Form 3160-5
(June 2019)UNITED STATES
DEPARTMENT OF THE INTERIOR
BUREAU OF LAND MANAGEMENTFORM APPROVED
OMB No. 1004-0137
Expires: October 31, 2021**SUNDRY NOTICES AND REPORTS ON WELLS**
Do not use this form for proposals to drill or to re-enter an abandoned well. Use Form 3160-3 (APD) for such proposals.

8. Well Name and No. FRODERICK 33 FED/508H

Froderick 33 Fed Com 718H (FKA 508H) API #: 30-025-52155

EOG respectfully requests an amendment to our approved APD for this well to reflect the following changes:

Figure 1: Cameron TA Plug and Offline Adapter Schematic

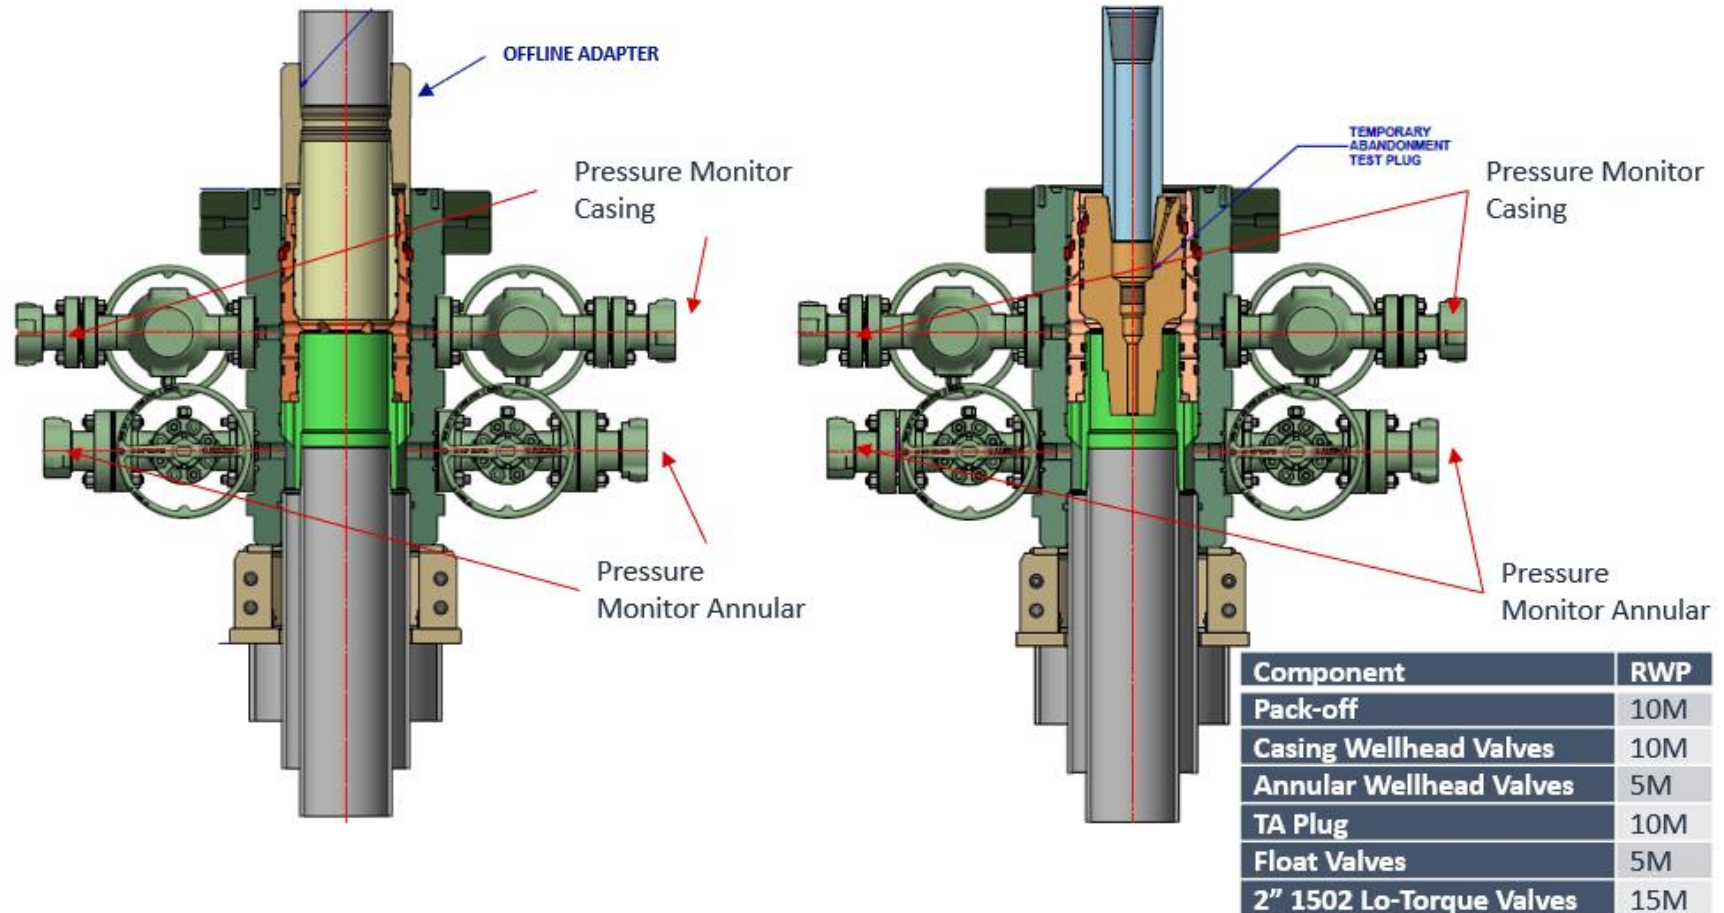
- c. Return line schematics can be seen in Figure 3.
10. Remove TA Plug from the casing.
11. Install offline cement tool.
 - a. Current offline cement tool schematics can be seen in Figure 1 (Cameron) and Figure 2 (Cactus).

Figure 4: Rig Placement Diagram

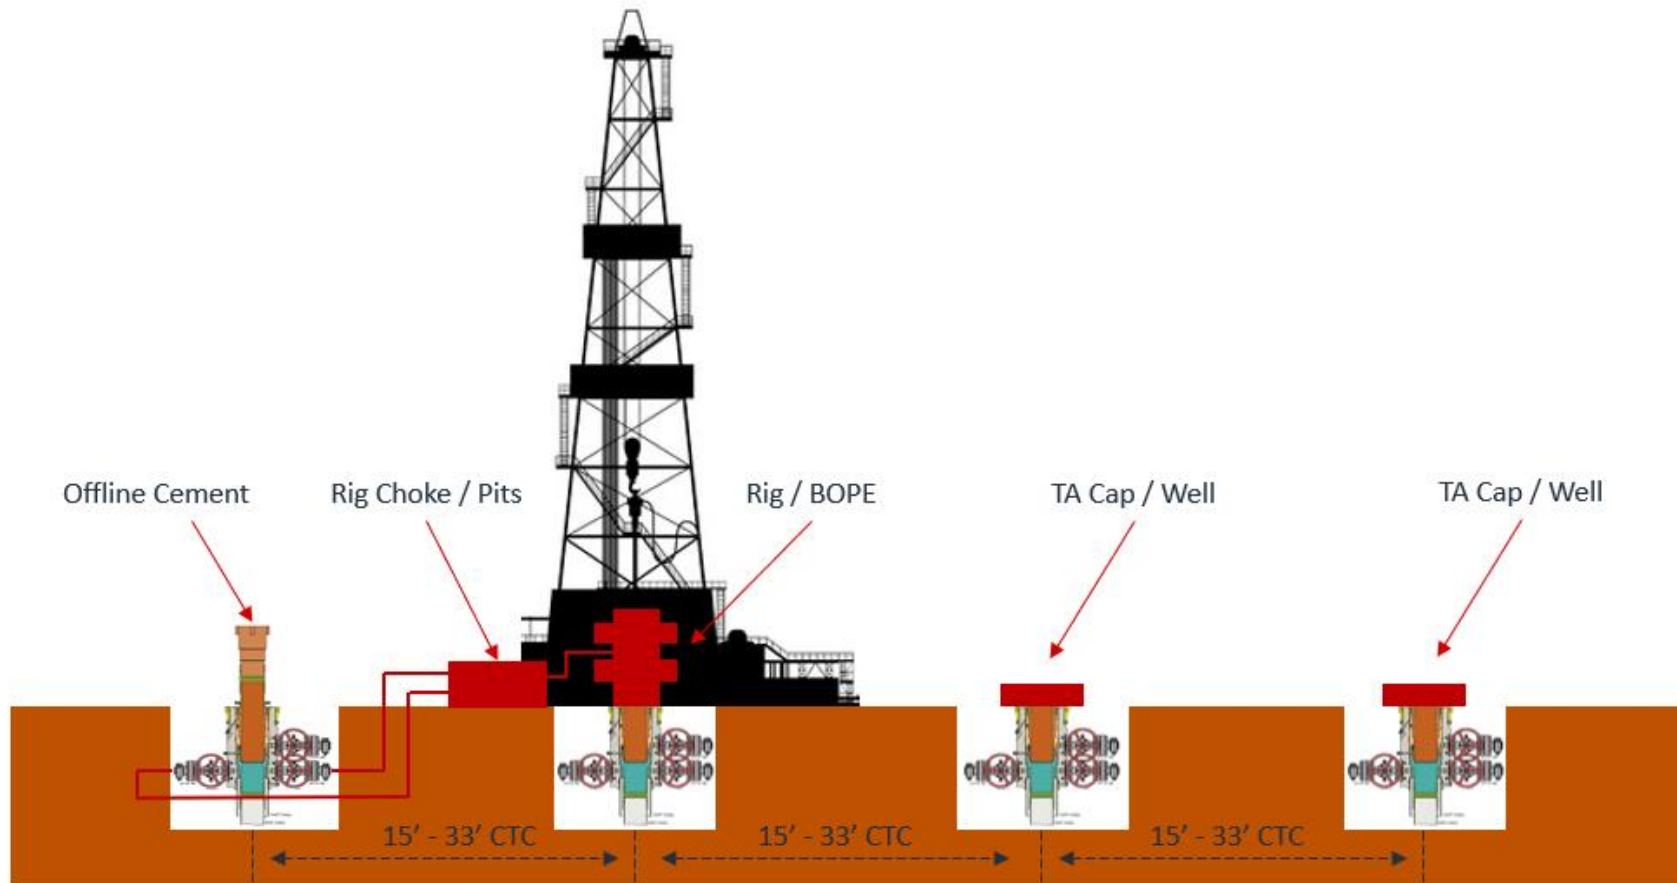
- e. Diagram for rig positioning relative to offline cementing can be seen in Figure 4.
9. Rig up return lines to take returns from wellhead to pits and rig choke.
